Memorandum

Subject: Case File: LU 19-225732 SOWA Alamo Manhattan Blocks
Otak Responses to Land Use Review Comments dated November 21, 2019

Otak Project No.:19050.100

OTAK PROJECT NUMBER
19050.2

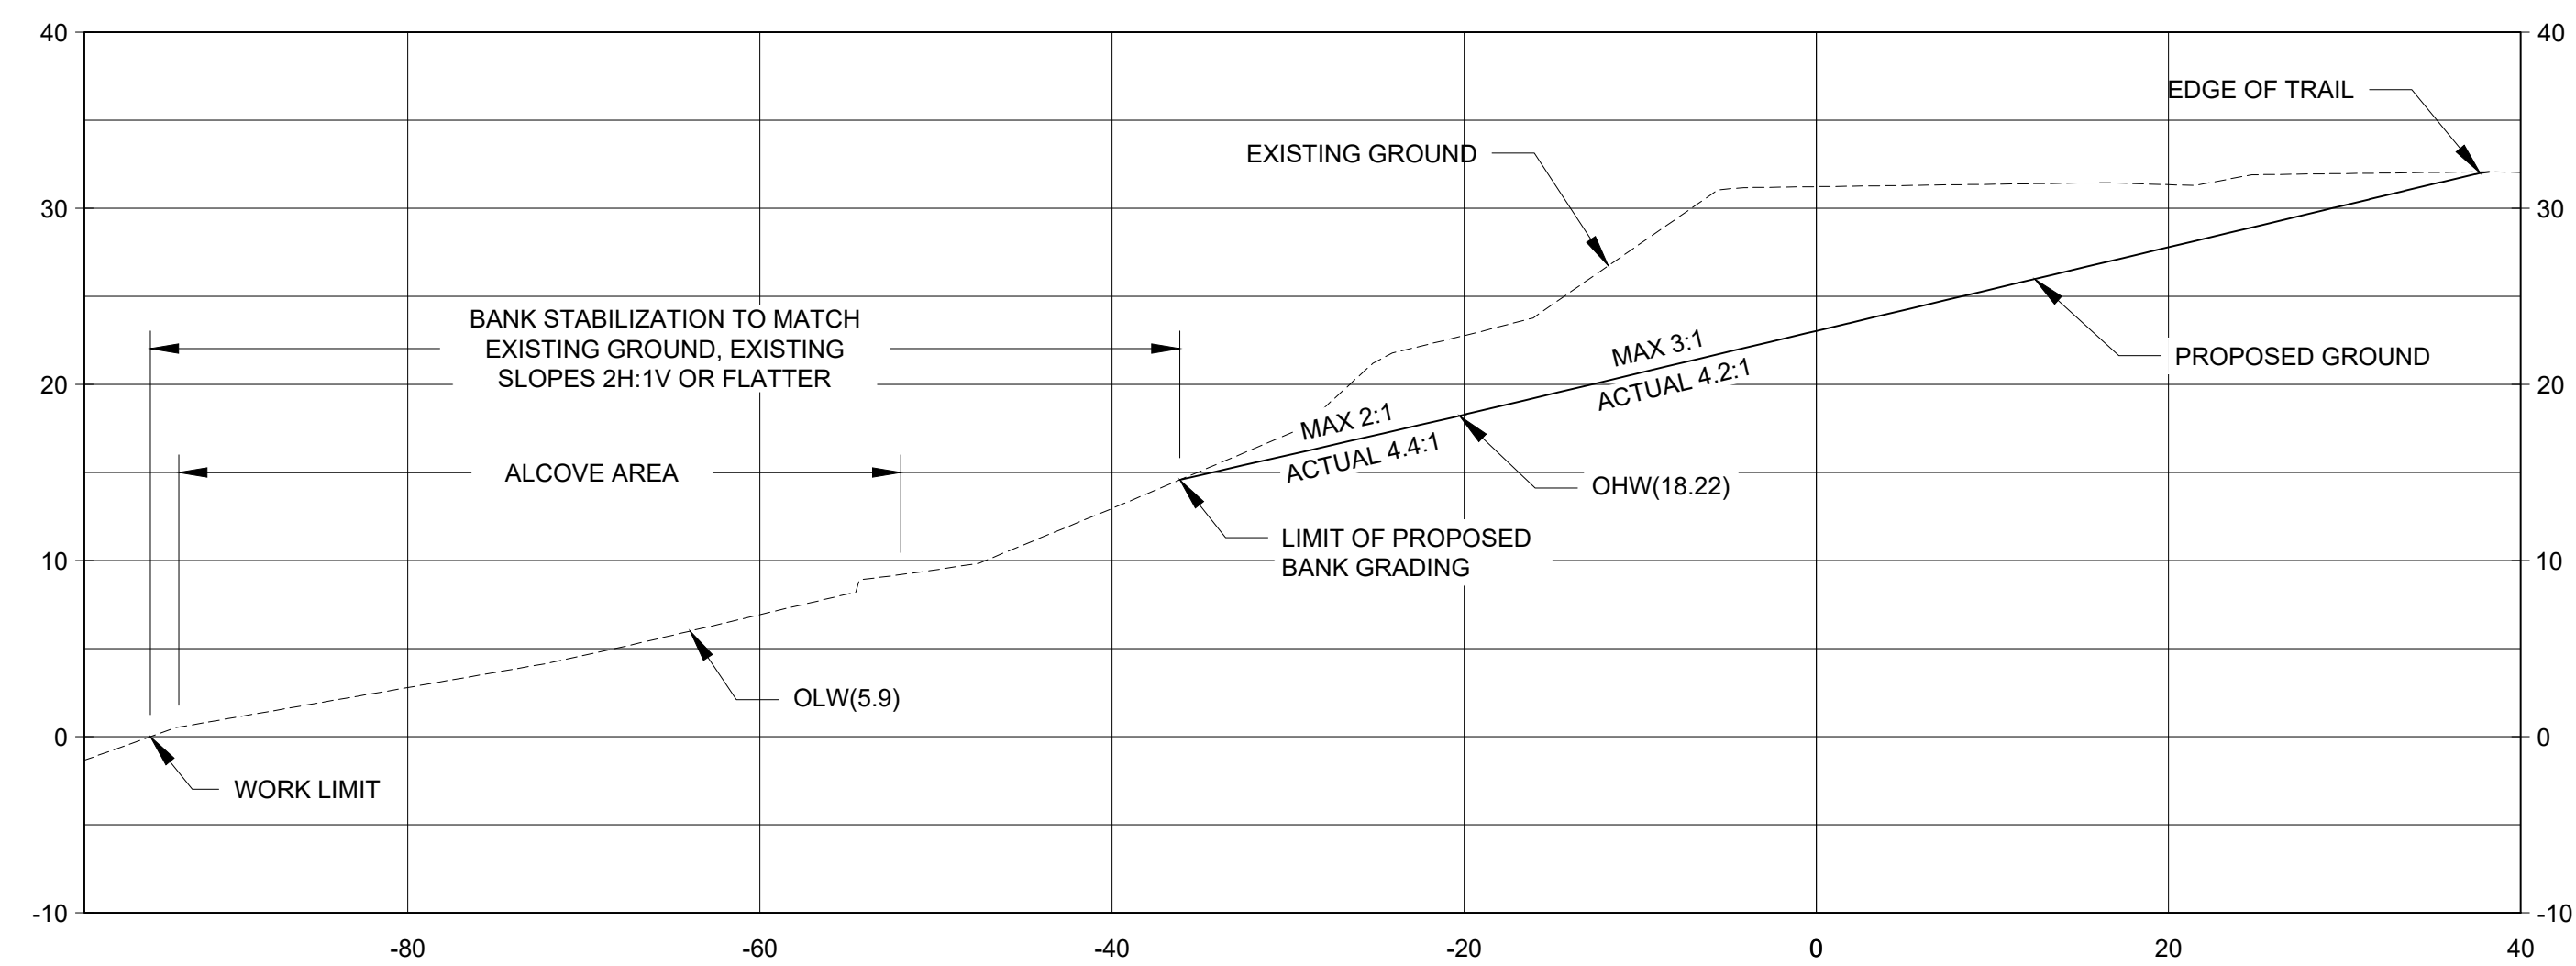
- a. *The proposal maintains a steep slope of 2:1 or 3:1 at all areas below top of bank (Sheet C2.2, C.110). This slope will require additional riprap and reinforcement. All decreases in slope appear to occur above ordinary high water (Sheet C2.2). Stable, naturalized riverbanks throughout the Willamette River are a minimum of 5:1 or shallower to 7:1 in order to allow native plantings to survive, provide adequate cover and slow moving margins for salmon to rest and rear, and to provide additional areas to escape high flows and predators. Notably, the areas of Ross Island are a 10:1 slope, Zidell was a 10:1 to a 5:1 slope in most areas, and Cottonwood bay is similarly a 6:1 to 7:1 slope below top of bank.*

The updated Greenway Review submitted is being revised to remove lawn, move the trails to the west, and create more space for bank re-grading and natural vegetation areas. Below ordinary high water the revised proposal calls for slopes between 2H:1V and 4H:1V, above ordinary high water it calls for slopes between 3H:1V and 5H:1V with some retaining wall required to prevent steeper slopes. Flatter slopes that would be required to fully naturalize the bank are not feasible due to the height of the existing steep bank and the available greenway width that must also accommodate other uses. Decreases in slope occur both below and above ordinary high water. Existing mild slopes are preserved, especially in flatter existing alcove areas at the north and south of the site (see attached plans)

Riprap is required for bank stability to protect against erosion from river flow and waves and wake. To provide cover, slow moving margins, and refuge for salmon as the water level rises, engineered large woody debris structures will be incorporated into the riprap slope. Below elevation 10 the large woody debris will be placed to create refuge and shelter, above elevation 10 large woody debris will be placed to create planting pockets for vegetation establishment because vegetation survival below elevation 10 is low even on mild naturalized slopes such as Ross Island and Cottonwood Bay. The established vegetation will provide the refuge and shelter functions. This approach is consistent with requirements of NMFS in their SLOPES V biological opinion.

Figure A-5b, Cross Section 14.48 – left bank grading and overlook structure

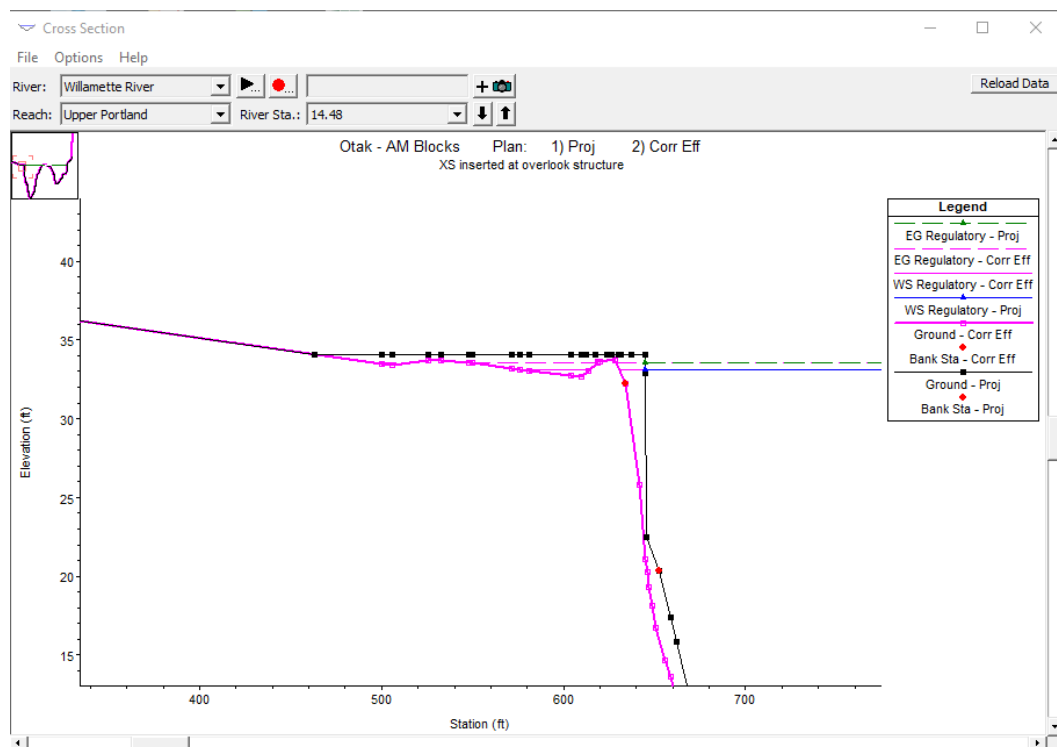
- b. *The overlook appears to occur in the regulated floodway which could cause mortality and stranding of federally protected endangered salmon and steelhead during high water events such as the 1996 flood event when this area was submerged.*

The Abernethy Overlook is also being eliminated. There will be no proposed structures within the regulated floodway. A no-rise analysis has been completed for the regulated floodway area along the project's riverfront area and it shows no impact to floodway.

A no-rise analysis was done that includes the Abernethy Overlook for the design presented in the original, allowing the design to proceed without CLOMR/LOMR review. For the proposed Design Review/Greenway Review resubmittal, the Abernethy Overlook has been eliminated and the bank laid back further at that location so there are no obstructions that could endanger federally protected endangered salmon and steelhead. The no-rise analysis that includes the Abernethy Overlook is attached to this response. The analysis will be updated with revised grading when required for permit issuance. Since the revised grading no longer has the overlook and the bank has been laid back further there should not be any issues with floodplain rise for the revised bank grading.
